33-51 Walsh Avenue and 2717-2745 Weston Road – Zoning By-law Amendment and Site Plan Control Applications – Appeal Report

Date: March 17, 2024

To: Etobicoke York Community Council

Planning Application Numbers: 22 207468 WET 07 OZ and 22 207467 WET 07 SA

Site Plan

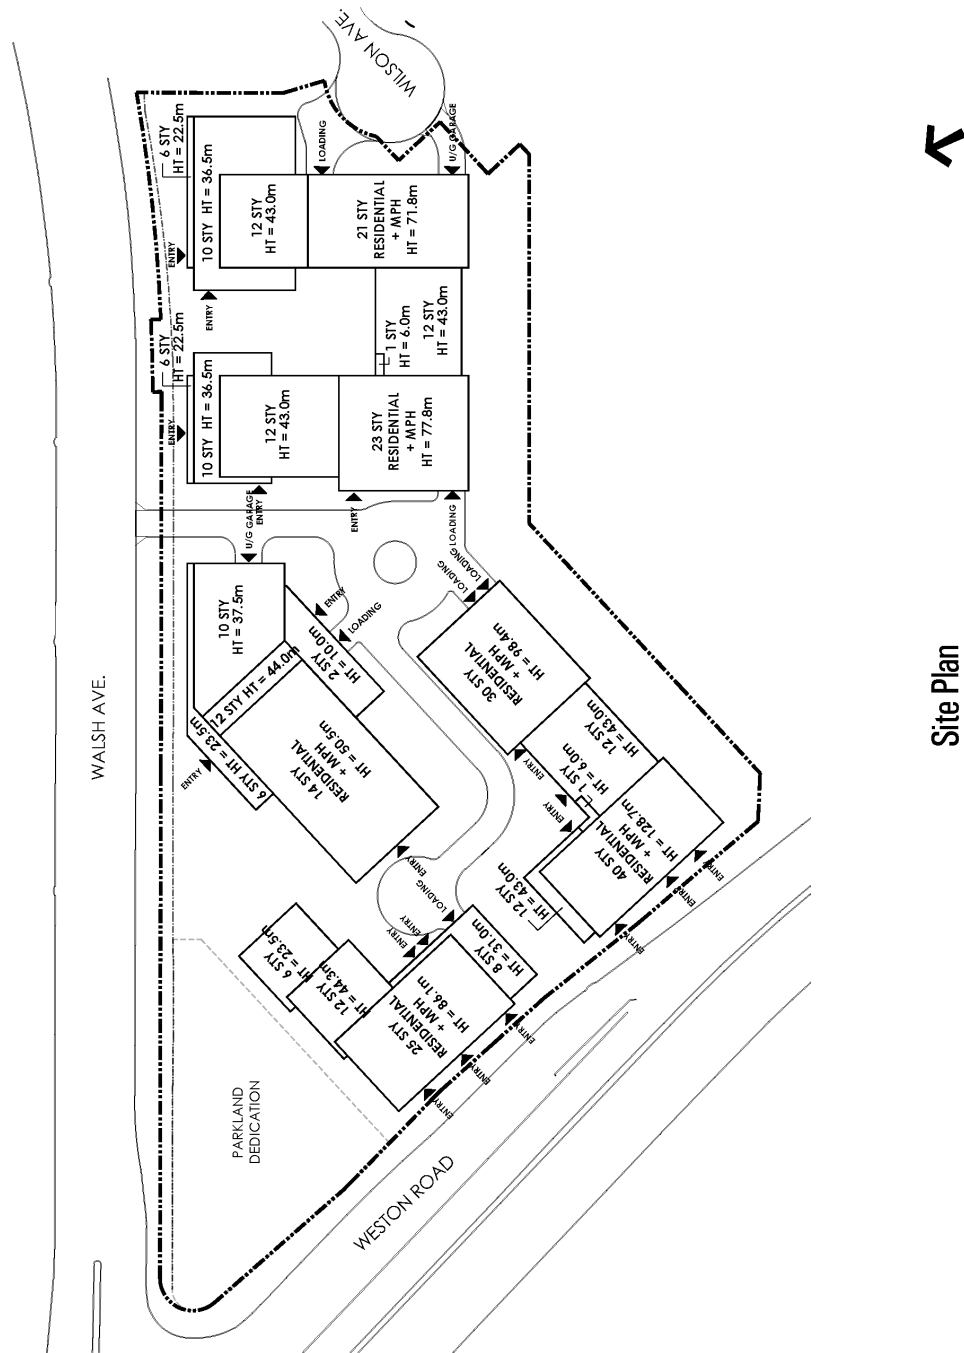
Vehicular access to the site is by way of two driveways, one from Walsh Avenue and the other from Wilson Avenue. The access points lead to a series of proposed driveways that stretch throughout the site providing access to the central vehicular turning circle, the underground garage and servicing areas for each building. The site layout results in "buildings behind buildings" with no public street frontage or access and allows for vehicles to be brought further into the site than is desirable. The site layout

The proposed site layout should be reorganized by extending the existing terminus of Wilson Avenue at the southeast corner of the site to provide a L-shaped public street to connect to Walsh Avenue and divide the site into two development blocks.

Currently, Buildings B and F are located away from public street frontages. This does not comply with the Public Realm and Built Form Official Plan policies and results in an inefficient site layout. The introduction of a new public street will assist in siting the proposed buildings, allowing all primary building entrances to have public frontage. The public street will provide access for all users to each building and eliminate the need for the number of proposed driveways and the turning circle all of which increase hard surfaces and do not support a Complete Streets approach. The new public street would be designed in accordance with the City's Development Infrastructure Policy and Standards Minor Local Residential Streets specifications.

The application is proposing an on-site public park located at the northwest corner of the site at the intersection of Weston Road and Walsh Avenue. The proposed location is not ideal as it is not well-connected to the abutting Neighbourhoods, would experience negative shadow and wind impacts and is adjacent to a busy vehicular intersection. The proposed on-site parkland should be relocated to the far east corner of the site, ensuring frontage on Walsh and Wilson Avenues and the recommended new public street extension.

Furthermore, the proposed 3.5-metre building setback from the park boundary is not acceptable as the minimum setback between park boundaries and an adjacent building face is five metres.
